Construction General Permit Compliance Evaluation Inspection Report

**Burma Road
Gotham Bay Road to Junction SH 97
Coeur d' Alene, Idaho**

**NPDES Permit Tracking Numbers:
IDR12C962, IDR12C968 and IDR12C974**

**Inspection date: March 25, 2014
Report completion date: May 21, 2014**

Photo No. 24, Photo by June Bergquist; 03/14/2014

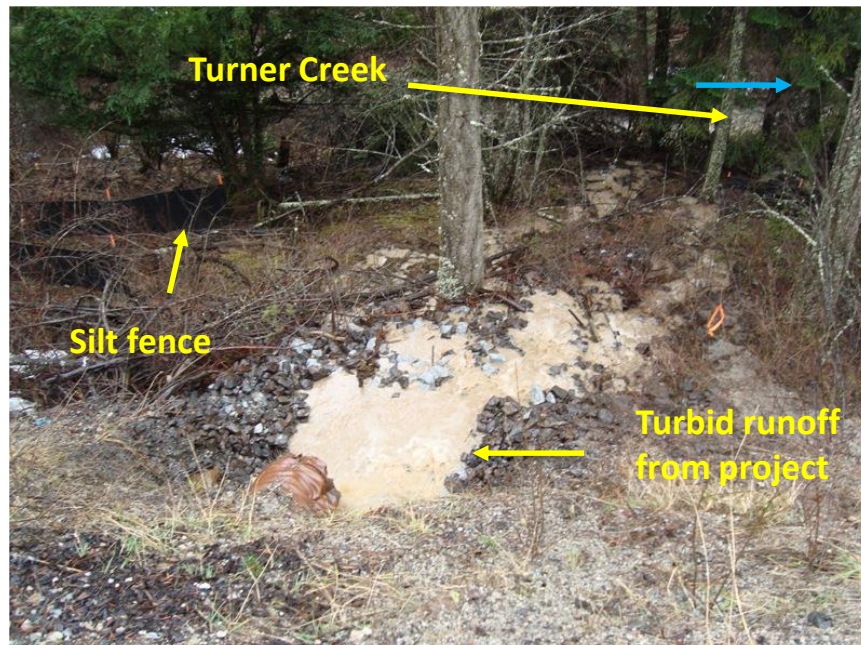
Turbid stormwater runoff from project flowing to vegetative area above Turner Creek

Photo No . 25 (P1000410)

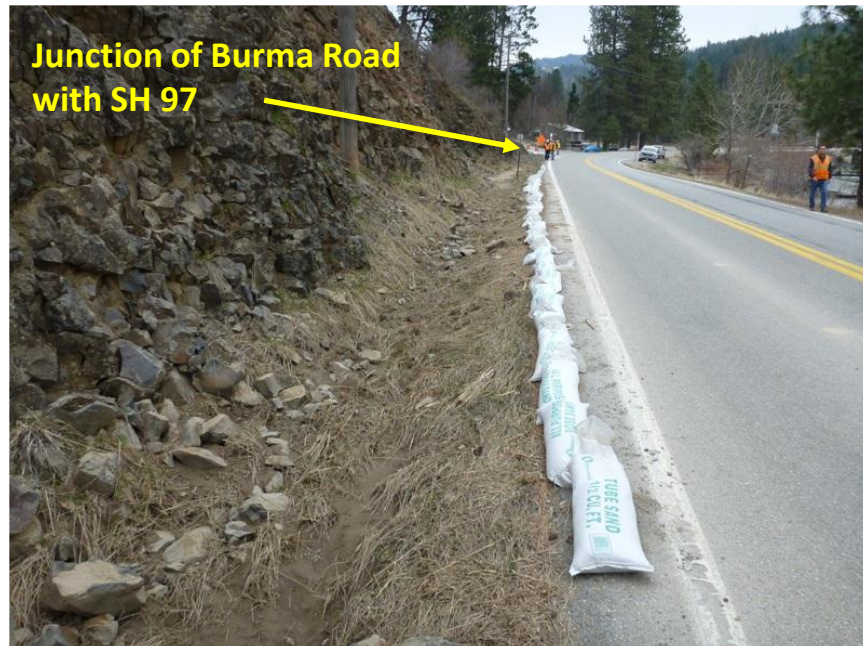
Facing south on Highway 97; ditch conveys some stormwater from the Burma Road project; at high flow, stormwater runoff has flowed across the highway with potential discharge to Lake Coeur d' Alene.
